AGNICO EAGLE

Re: Response to Comments on Meadowbank Complex Interim Closure and Reclamation Plan

Attachment A: Meadowbank Complex Tailings Storage Facility Thermal Cover Model

Attachment B: Response to the Kivalliq Inuit Association’s Comments (March 2, 2026) and Meadowbank
TSF Thermal Model Temperature Contour Plots

Figure 1: Arsenic concentration in the TSF runoff for varying cover thicknesses

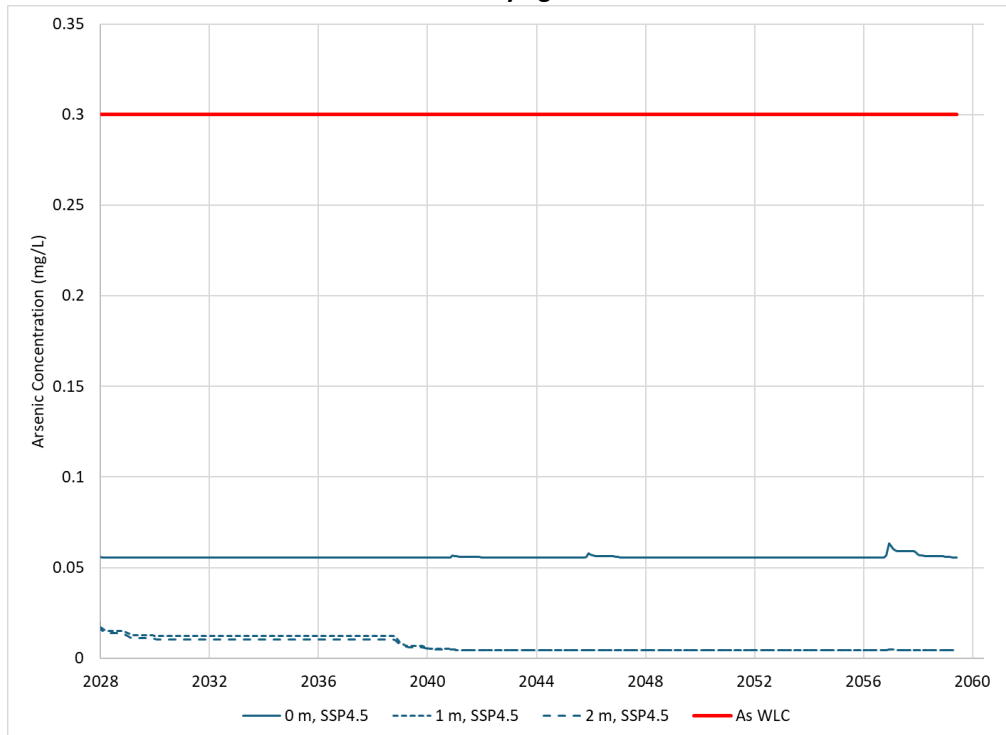
Comment b) Thermal model results

Hydrologic and thermal modelling indicate improved thermal performance with increasing cover thickness, however, and more importantly, the contaminant transport modelling indicates very minimal to no improvement in water quality with an increase in cover (Appendix 6-JB). As noted in the above response, maintaining saturation at or above 85% is the important metric. As described in Appendix 6J-A, a cover of less than 1 m is required to maintain saturation. Additionally, even if the tailings are fully thawed, the cover will maintain a saturation at or above 85%. Therefore, the contaminant transport model showed significant water quality improvement from a *no-cover* scenario to a 1 m cover, but very little to no improvement going from a 1 m cover to a 2 m cover. An example of these results is provided in Figure 1 for arsenic. Therefore, a 2 m cover is predicted to meet closure criteria for chemical stability, and a thicker cover is not necessary. Improved thermal performance does not provide any improvements in water quality.

Figure 2 Thaw Duration Within the Tailings for the 2 m NAG Waste Rock Cover

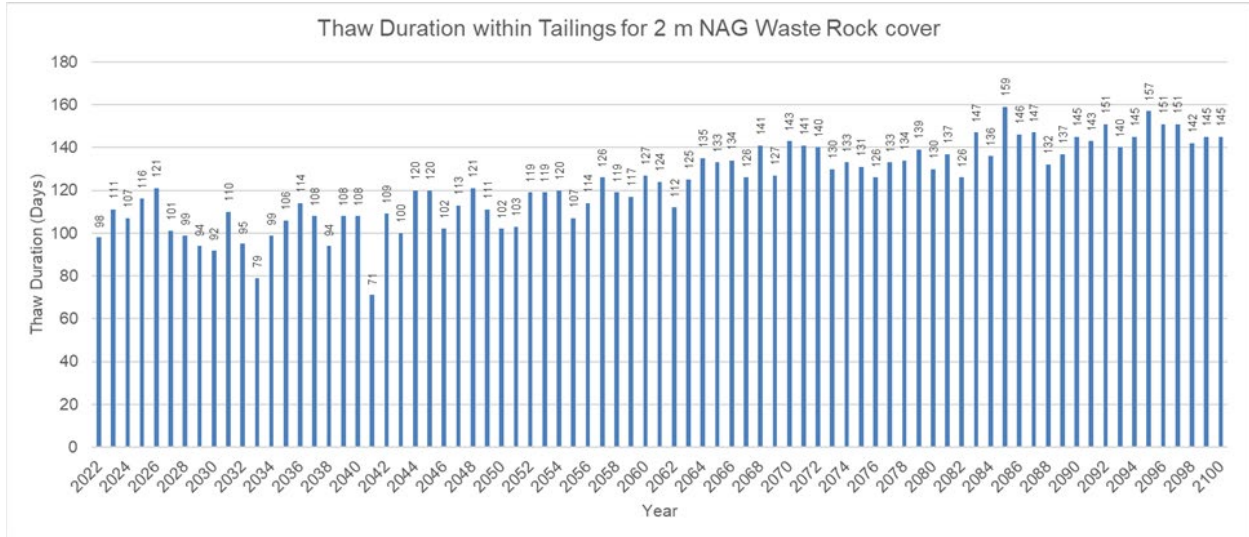
Comment e) Seasonal thaw and duration

Where Table 2 presents *maximum thaw depth*, the results do not show *thaw duration*. For example, while a 2 m cover may experience thaw of up to 0.97 m into tailings, the thaw front is dynamic and is predicted to shrink/decrease back into the NAG cover during colder periods of the year. Figure 2 shows the thaw duration predicted by the thermal model at the *boundary* of the NAG cover and tailings (Section 3.2 of Attachment B). The analysis shows that thaw at the boundary can persist from 71 to 159 days, and the cover is predicted to be frozen for the remainder of the year. Therefore, thaw is predicted to be seasonal and not permanent.

It should be noted that these results are for the boundary between the NAG cover and tailings. If a location slightly lower into tailings was selected, thaw duration would be lower due to delayed and reduced thaw penetration. This is presented in Appendix A of Attachment B of this response package, where Agnico Eagle produced thermal contour plots. The contour plots show the seasonal advance and retreat of the thaw front through the NAG cover and tailings, and provides an additional dimension of analysis showing the thaw duration versus depth.

Figure 3: Modeled and thermistor temperature data compared at 2.15 m below surface

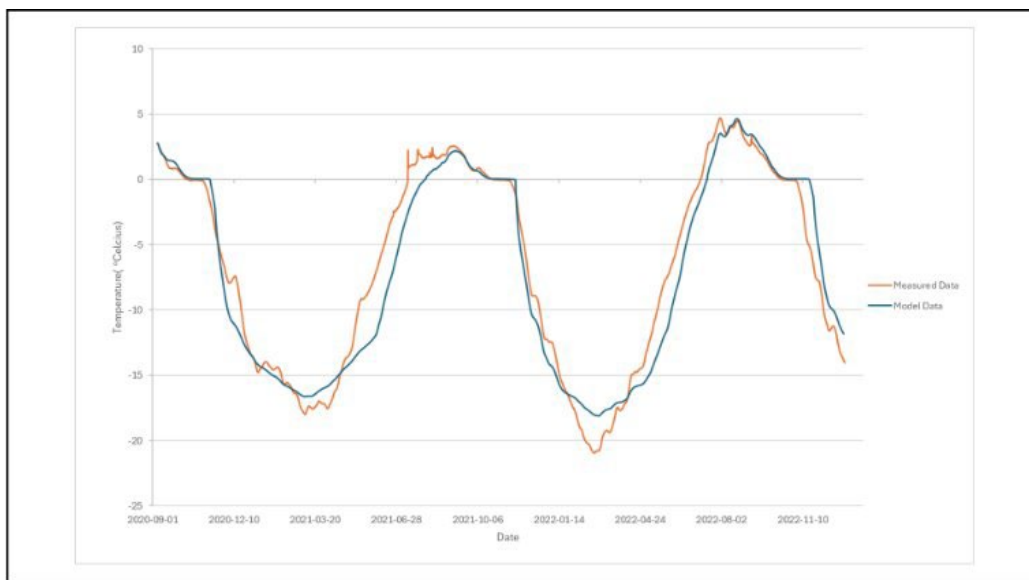
Comment c) Model calibration

Thermal calibration was completed to validate the thermal model to monitoring data, prior to modelling future projections. Details of the calibration are provided in Attachment A of this response. An example of this calibration exercise is provided below in Figure 3, where the model (blue line) reproduces the observed temperature (orange line) very well.
